Additional/Revised Material Submittal Form

Project Name: 34th St. Townhouses

Project Address: 211,219,227,235 W. 34th St. Garden City, Idaho, 83714

DESIGN REVIEW REPORT AND DECISION

SHEET
 A4.0

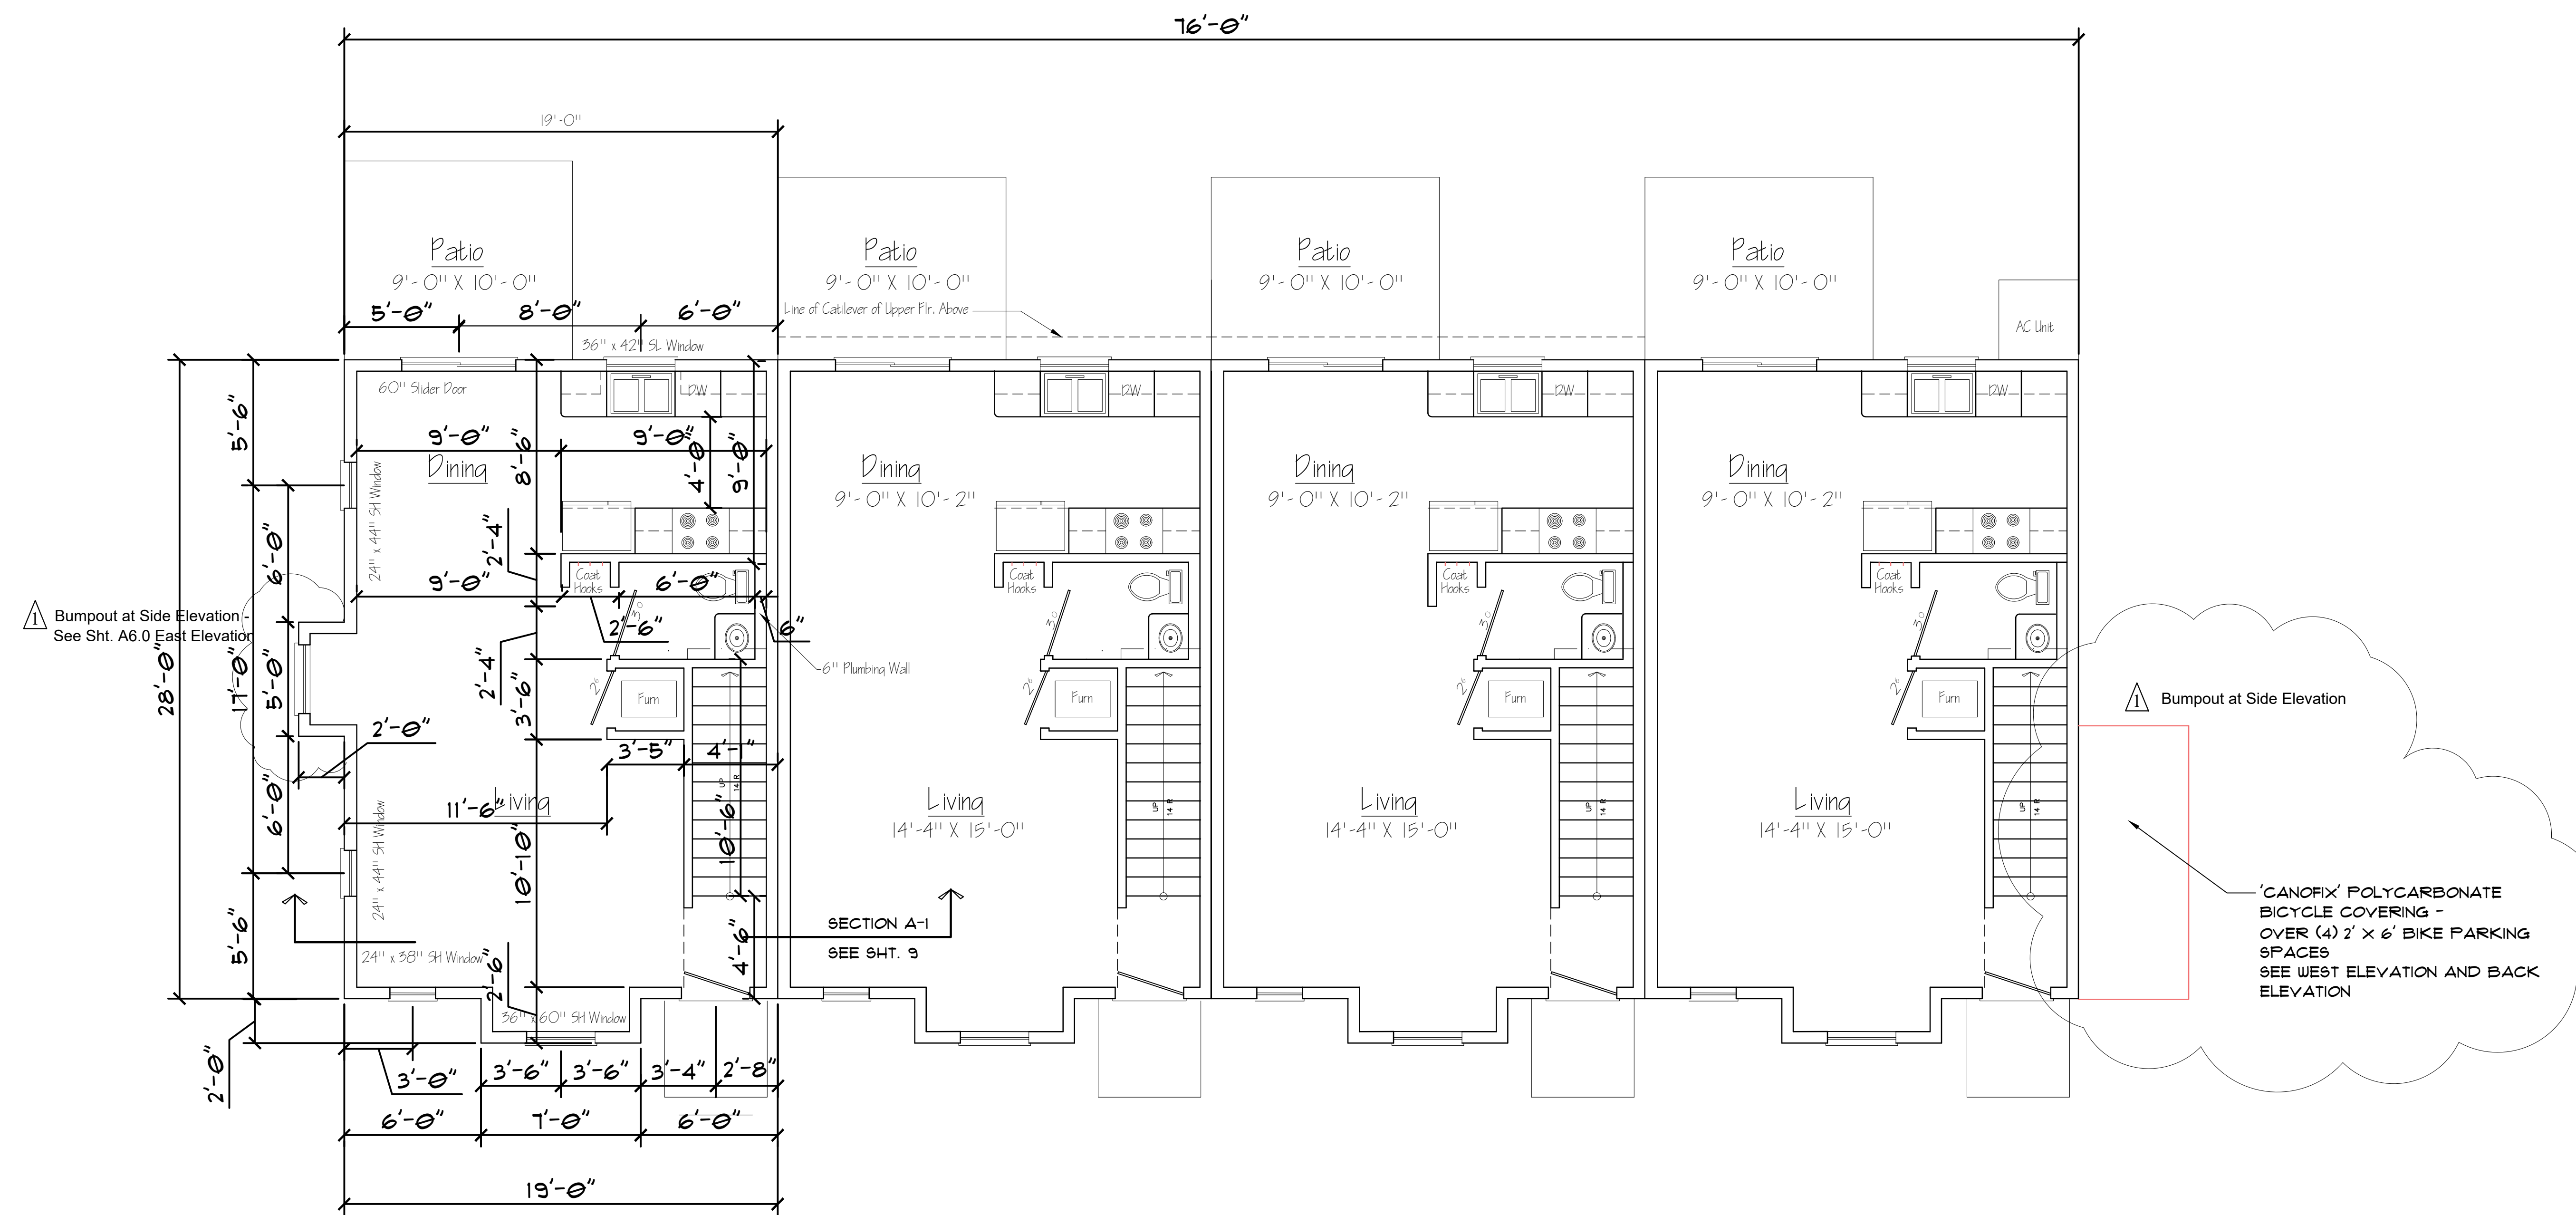
▲ Bumpouts at Side Elevations

**SHEET
 A5.0**

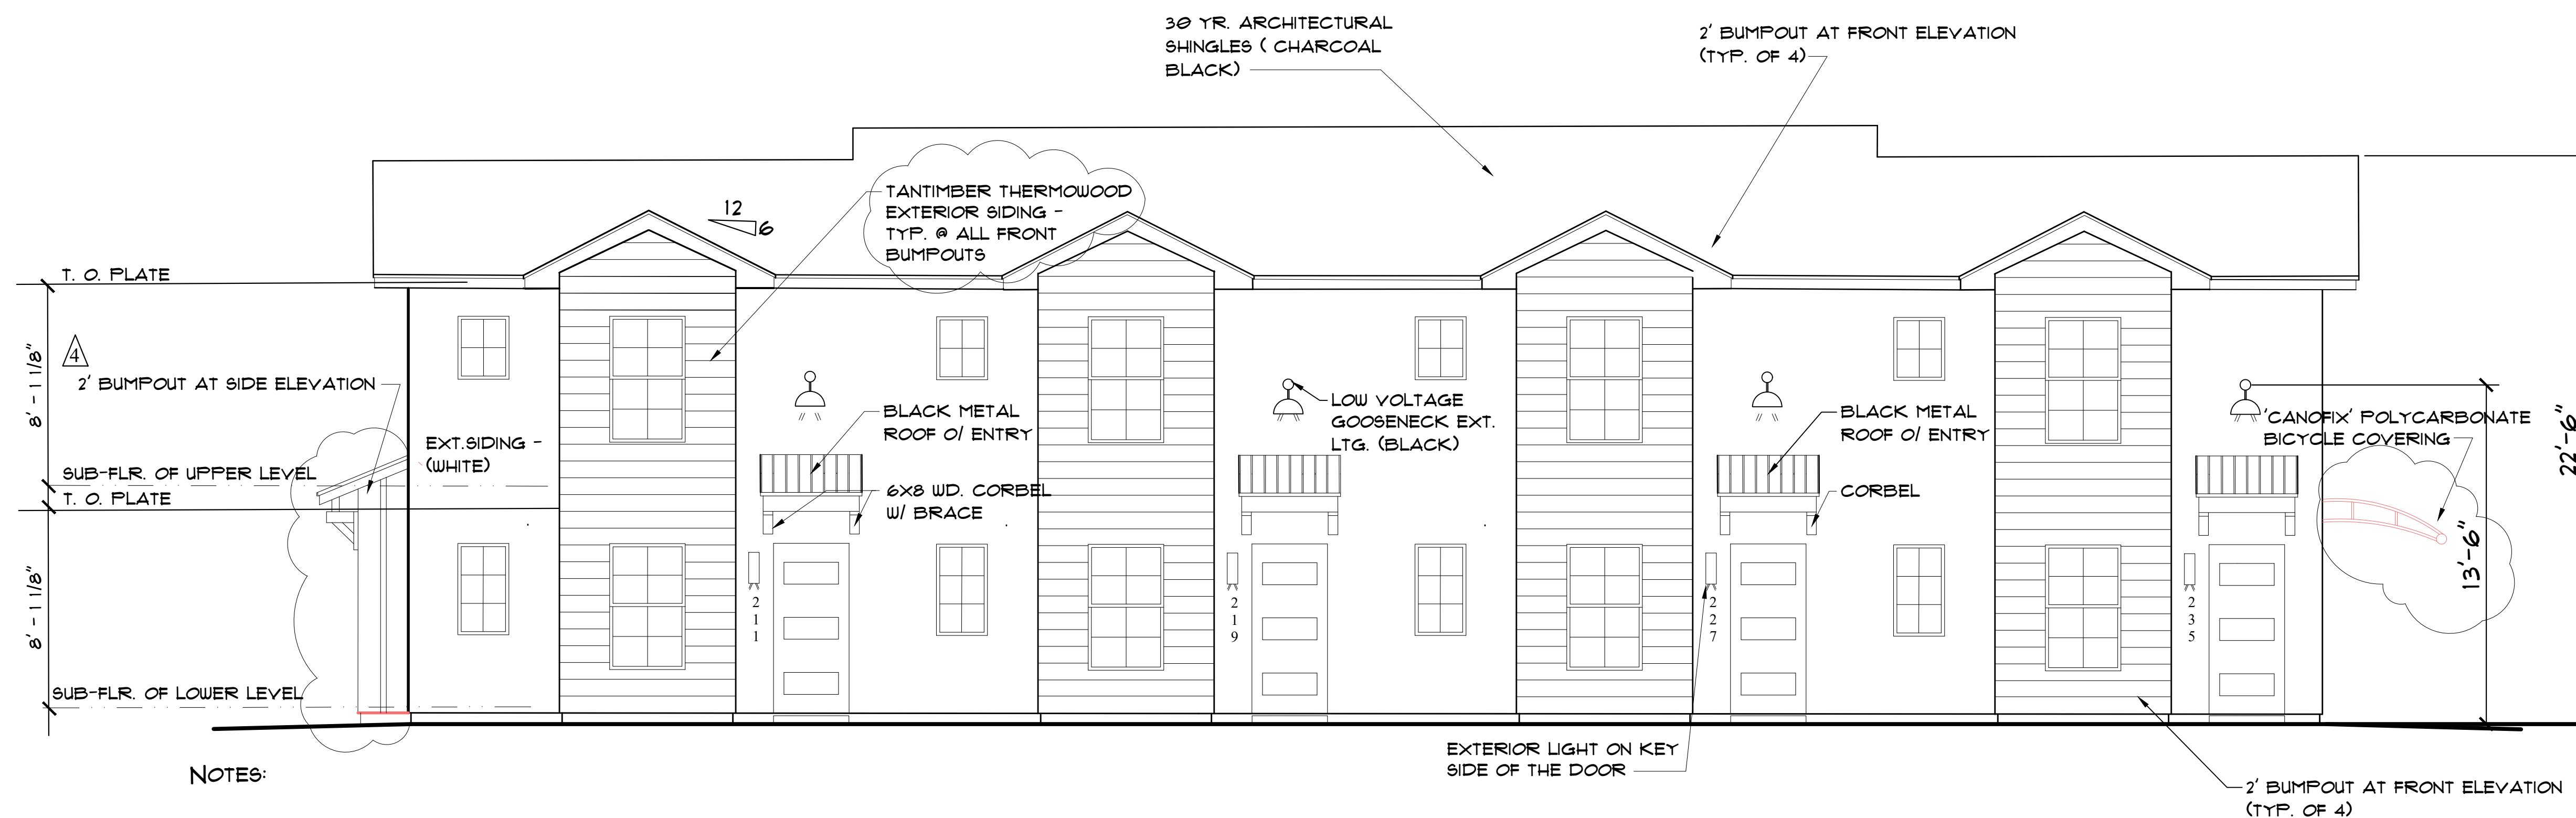
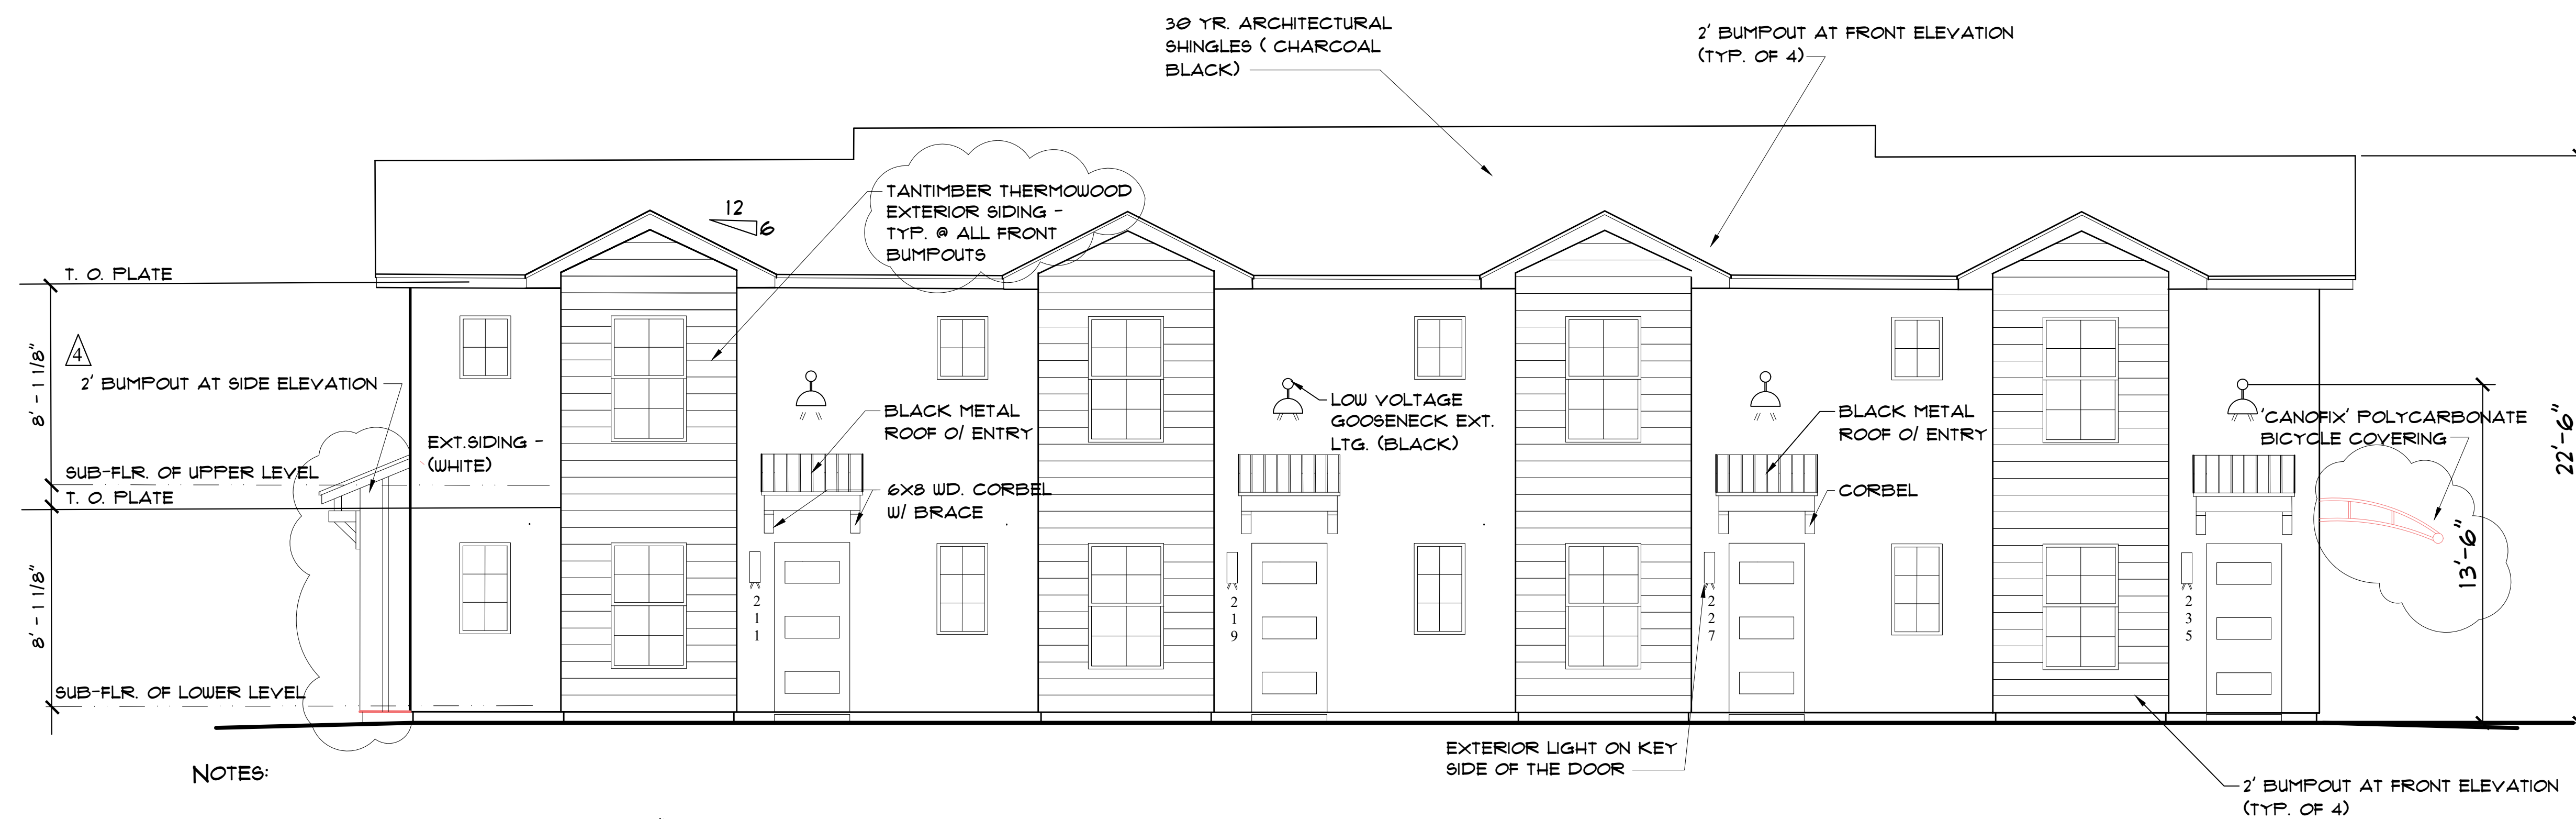
3 Cantilever at (2) Units

- 1 Exterior Materials Colors
- 2 Shed Canopy above Door
- 3 Cantilever at Back Elevation
- 4 Bumpouts at Side Elevations

**SHEET
 A3.0**

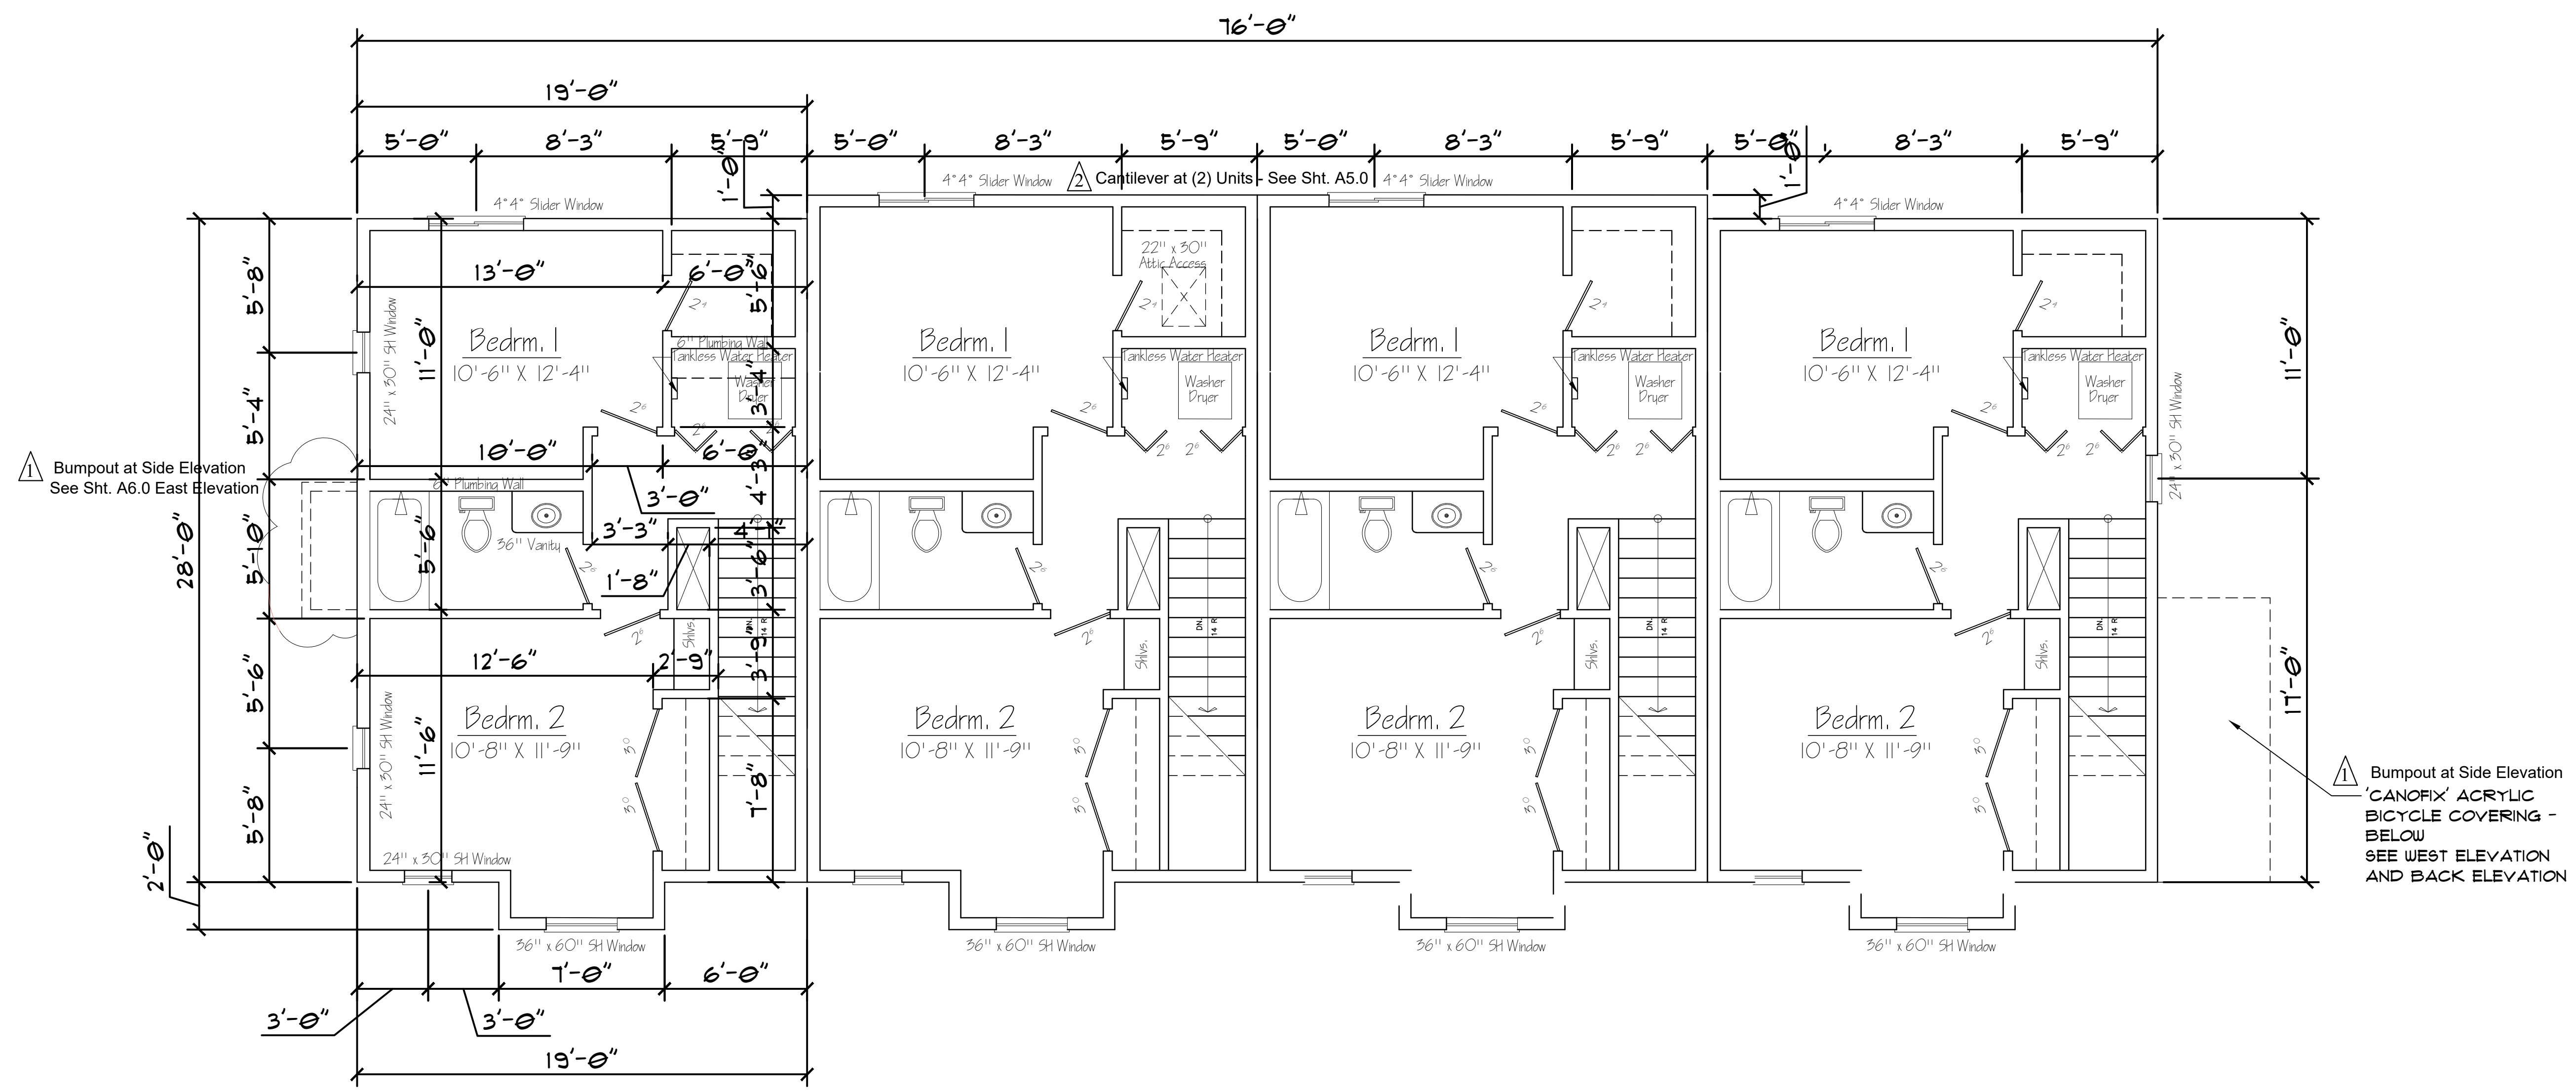
- ▲ Bumpouts at Side Elevations
- ▲ Cantilever at (2) Units
